From: Simon Davis
Sent: 08 July 2020 12:30
To: Planning Scanning
Subject: FW: Yapton - Drove Lane Design Code - Update

From: Simon Davis
Sent: 08 July 2020 12:28
To: Sparkes, Jessica [REDACTED]
Subject: RE: Yapton - Drove Lane Design Code - Update

Building Typologies

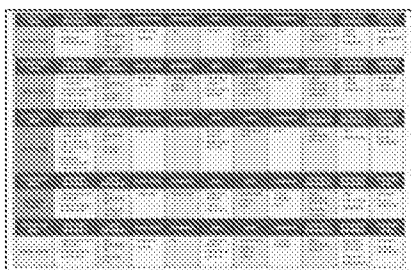
Thank you for the summary tables which are helpful. Would it be possible to provide a single table somewhere in the Code to provide easy comparison of the areas? E.G. -
